Rosamond High Early College Campus Cafeteria Building
SOUTHERN KERN UNIFIED SCHOOL DISTRICT
F&M Project No. 2990
Bid Clarification No.3; Page 1 of 2

BID CLARIFICATION NO. 4

July 18, 2023

LIGHTING PLAN

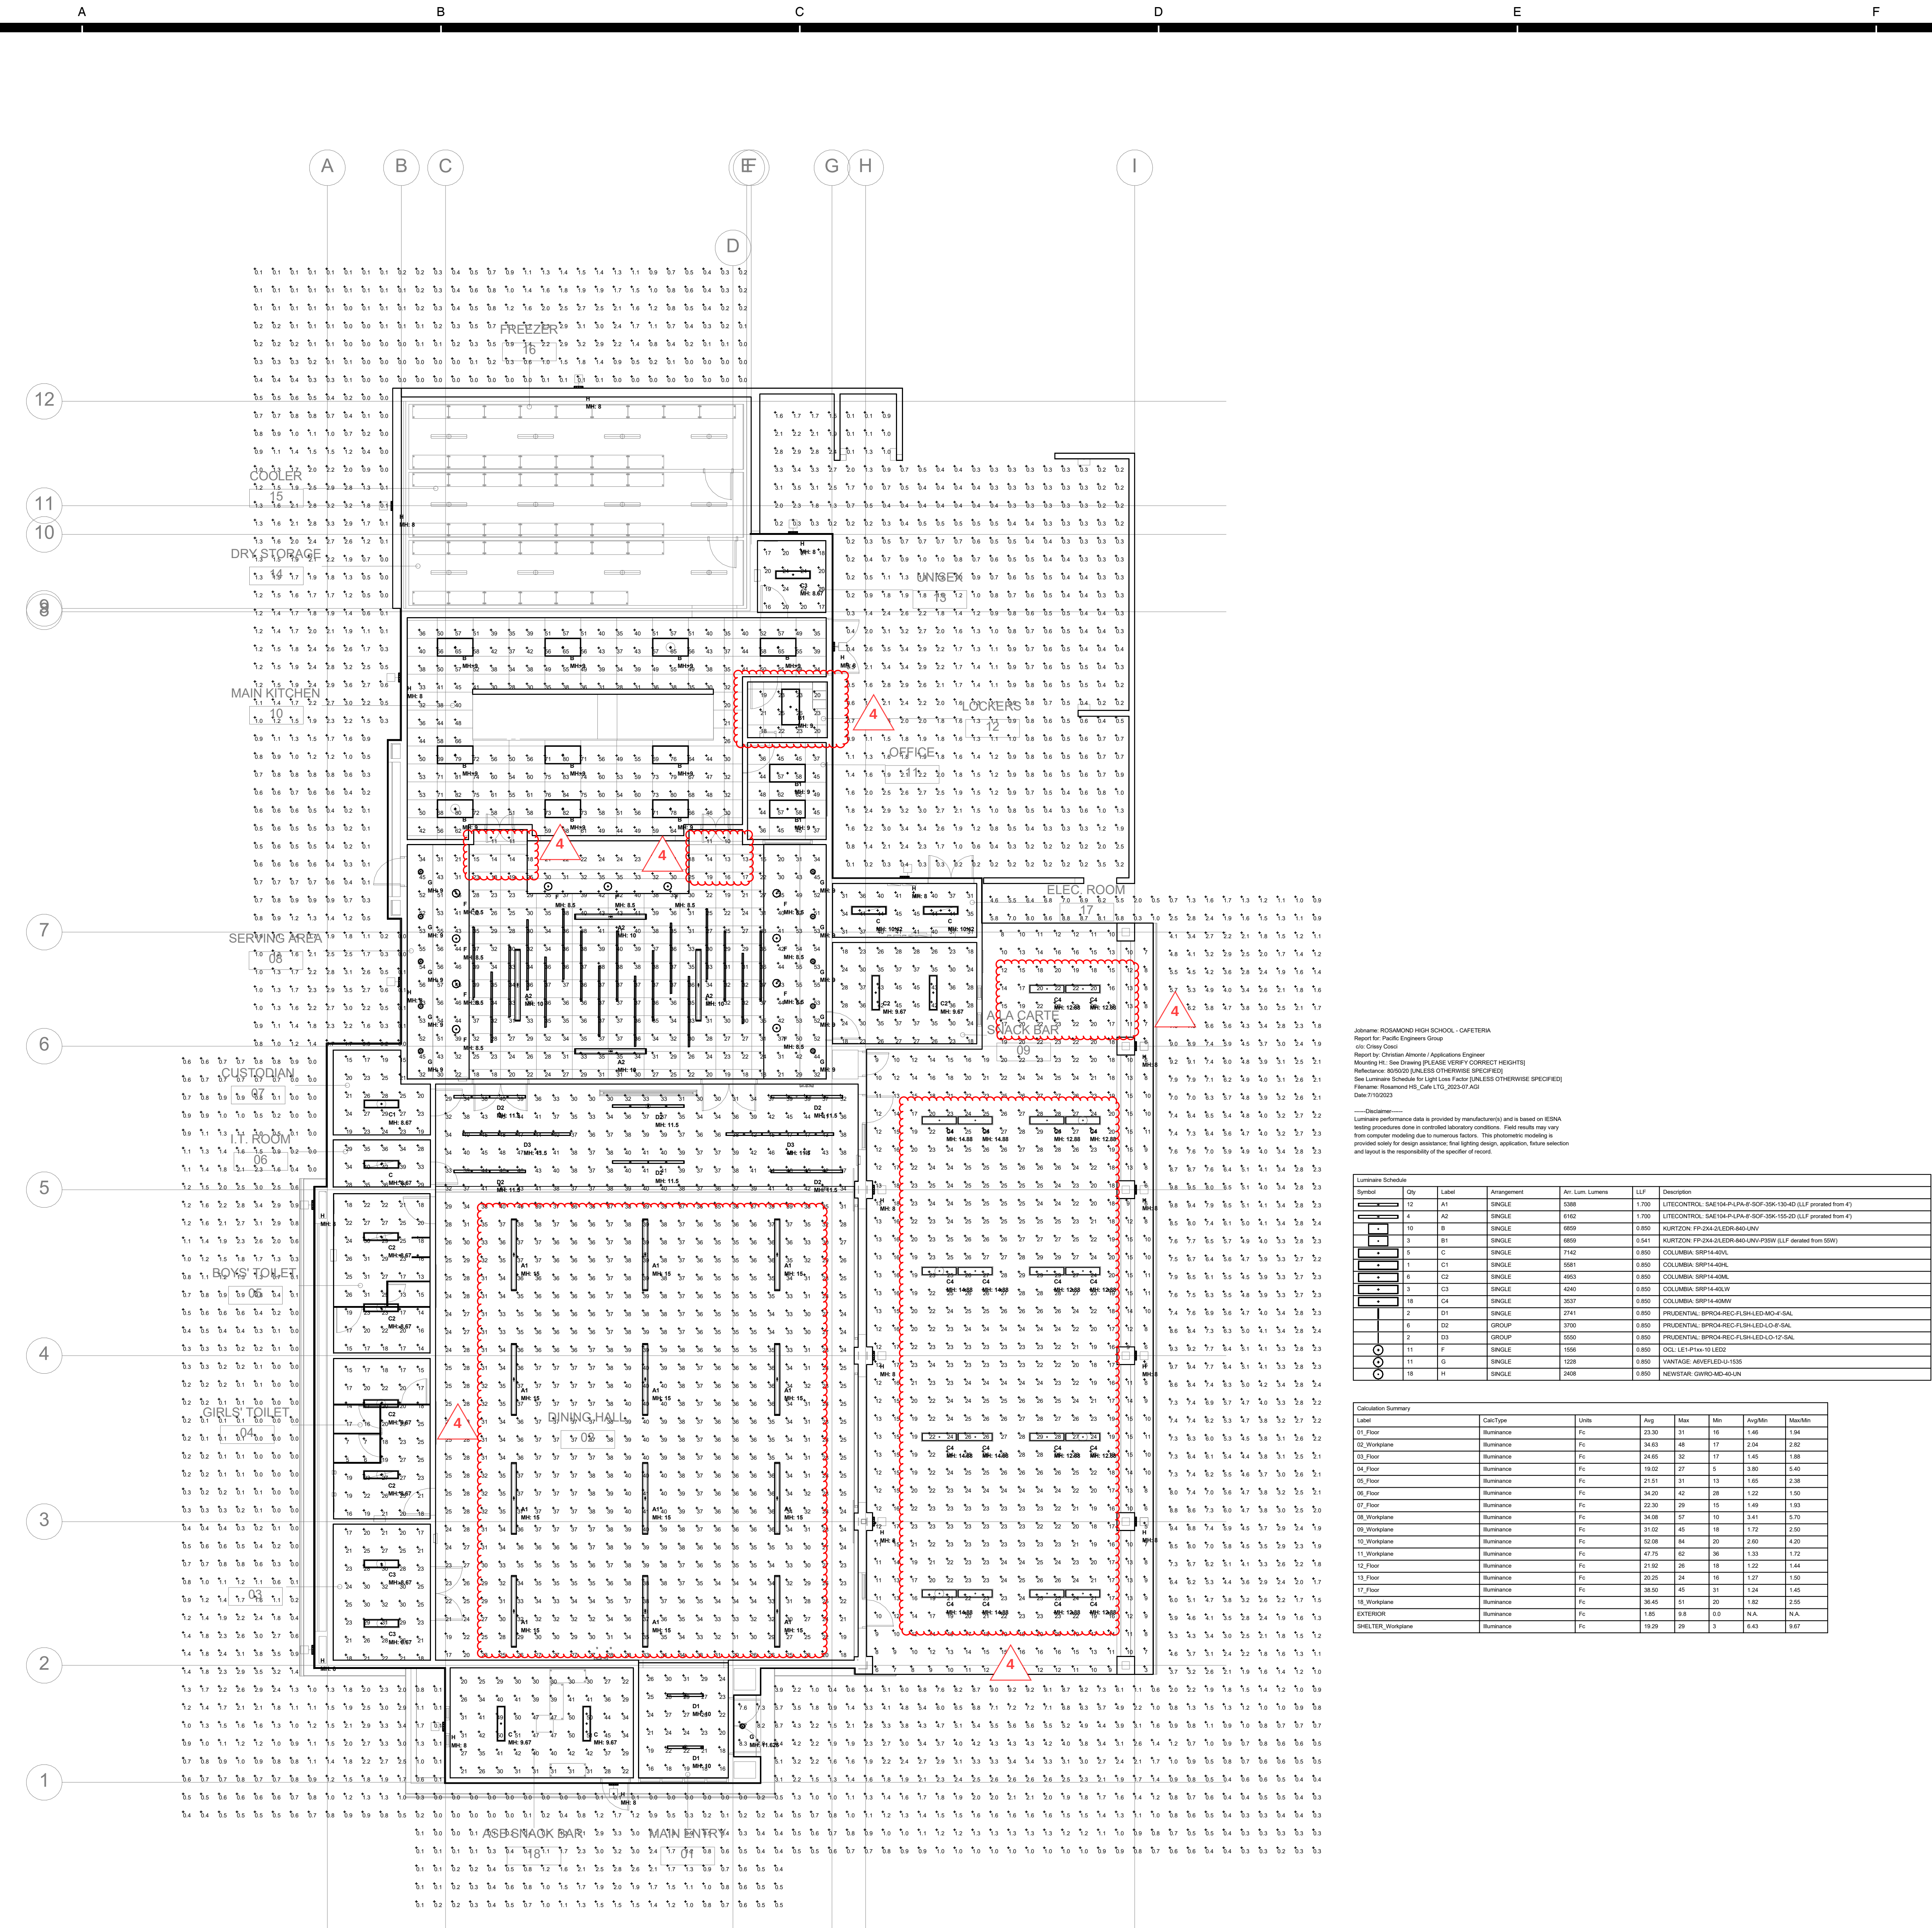
18. E201 – Electrical Site Plan – “Bid Clarification No.4”, with revision clouds as attached hereto.
19. E401 – Lighting Plan – “Bid Clarification No.4”, with revision clouds as attached hereto.

PHOTOMETRIC PLAN -
NORMAL

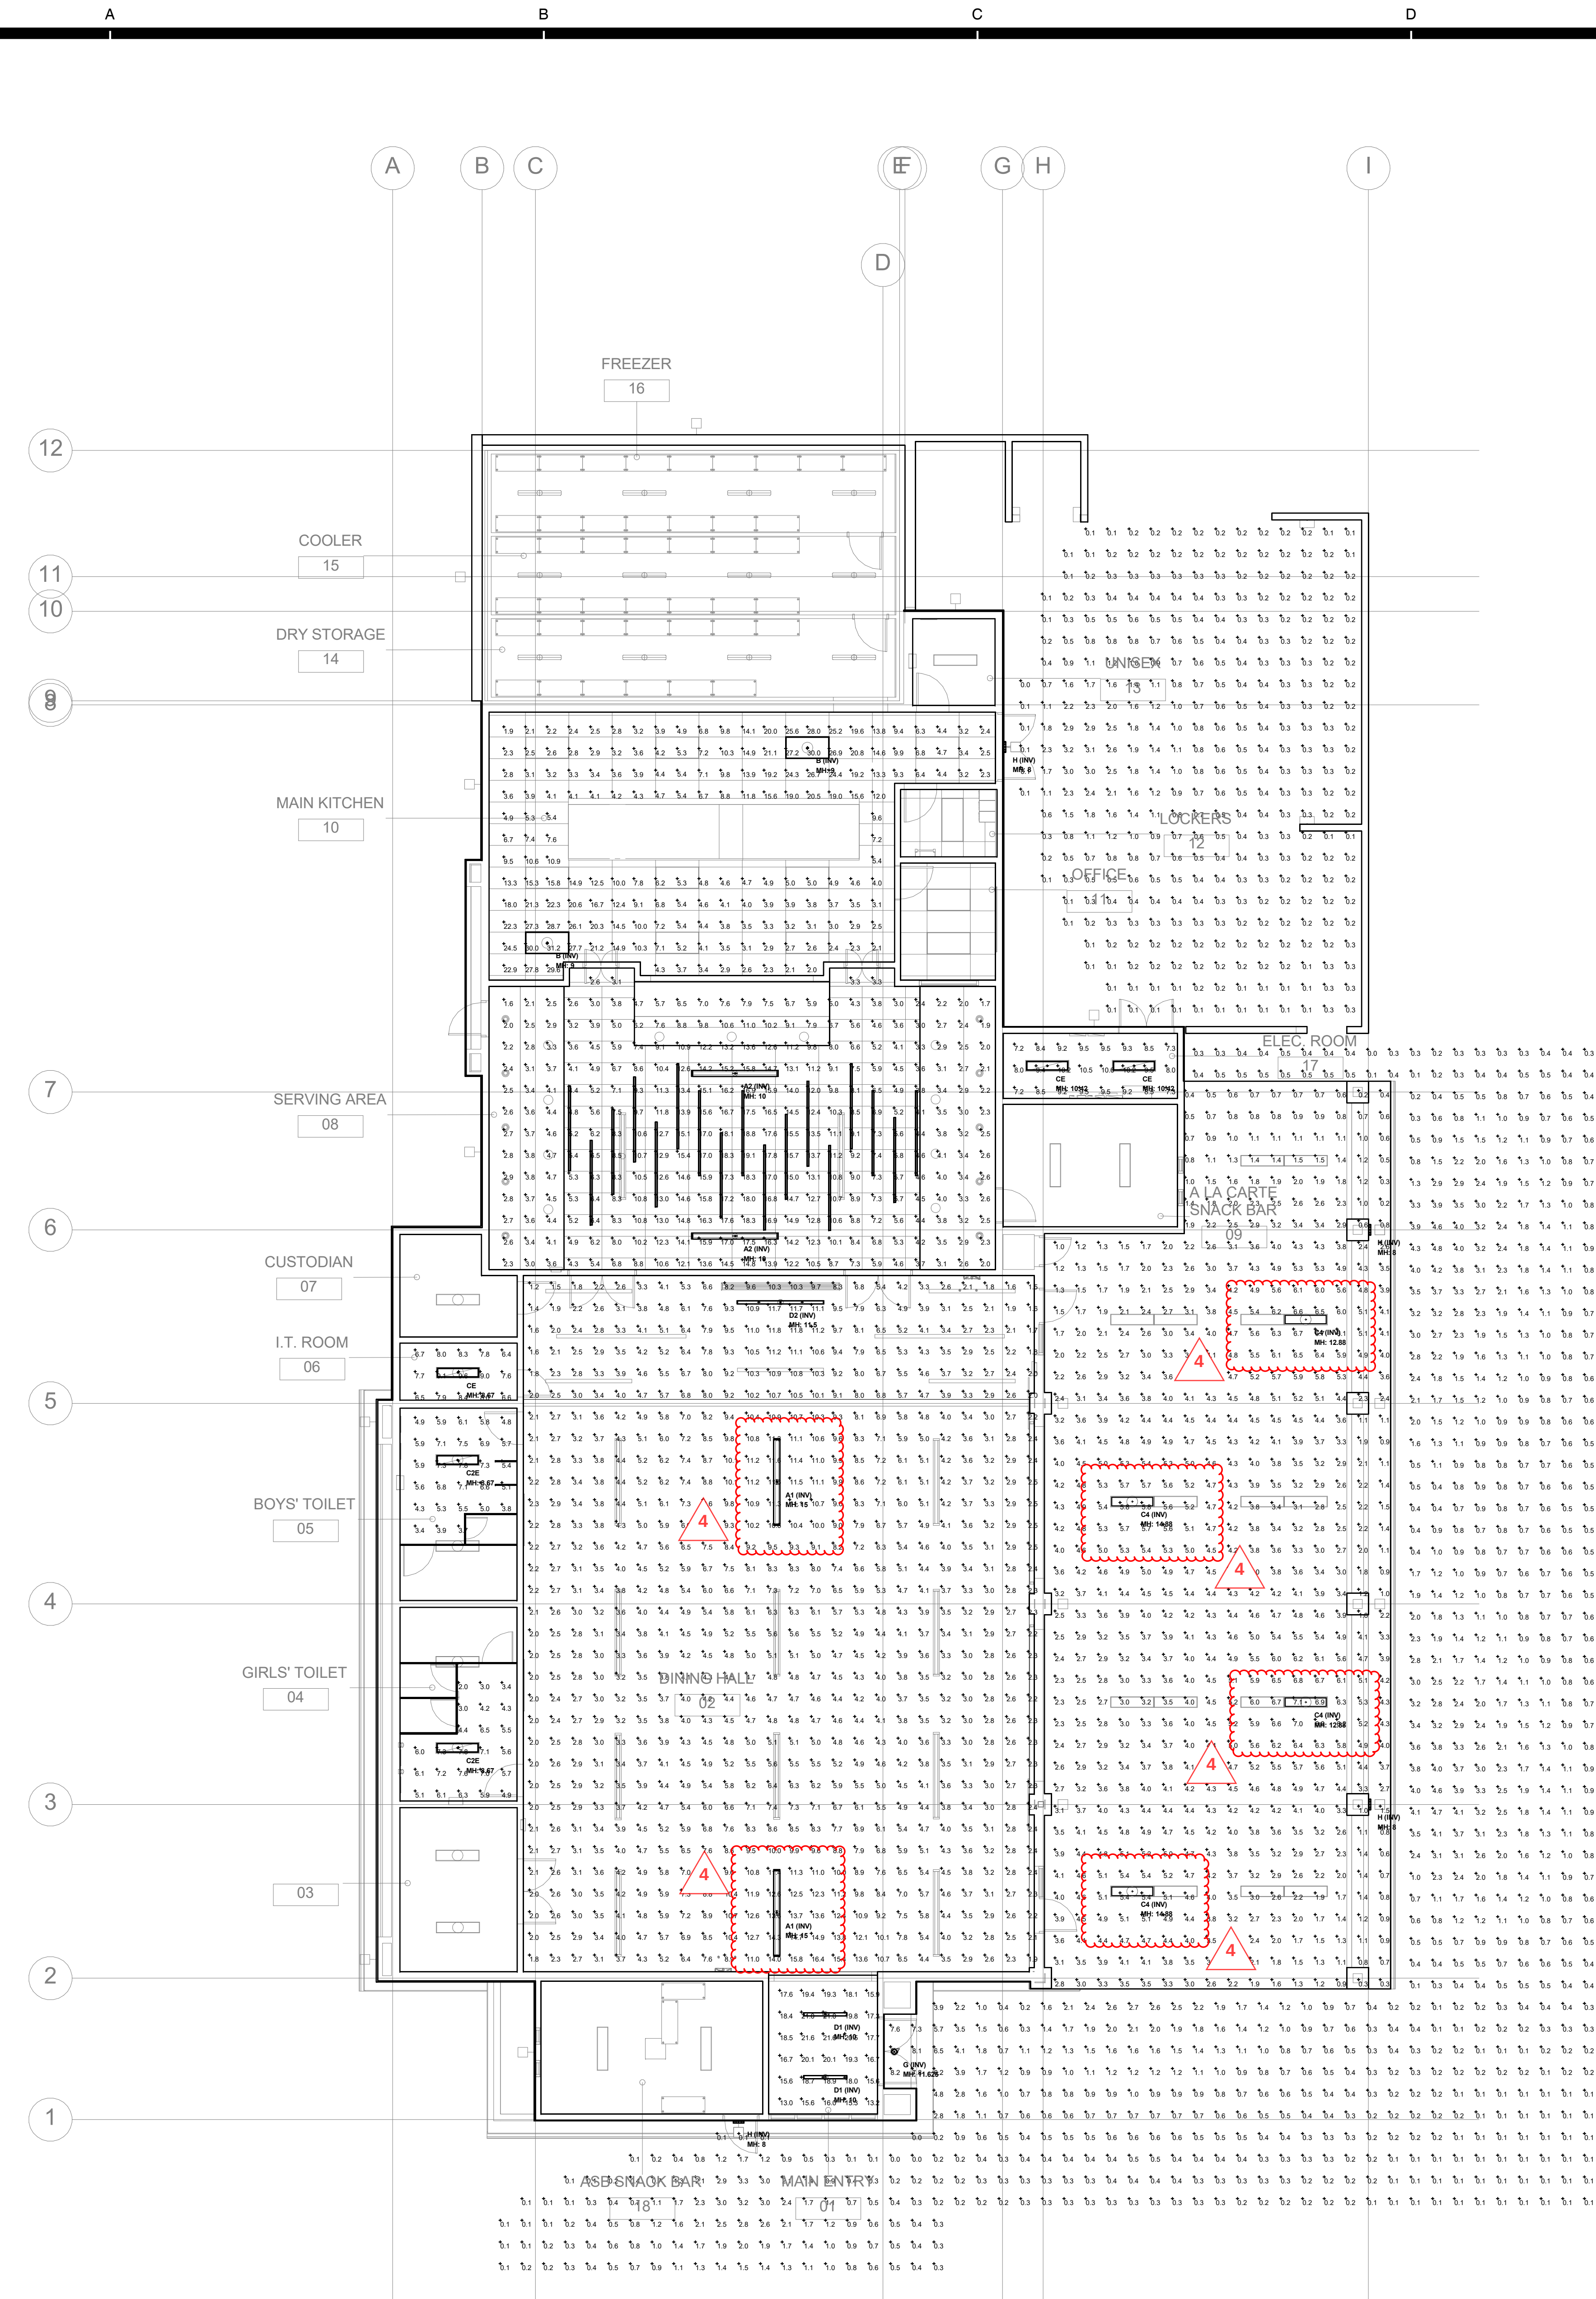
20. E403 – Photometric Plan – Normal – “Bid Clarification No.4”, with revision clouds as attached hereto.
21. E404 – Photometric Plan – Egress – “Bid Clarification No.4”, with revision clouds as attached hereto.
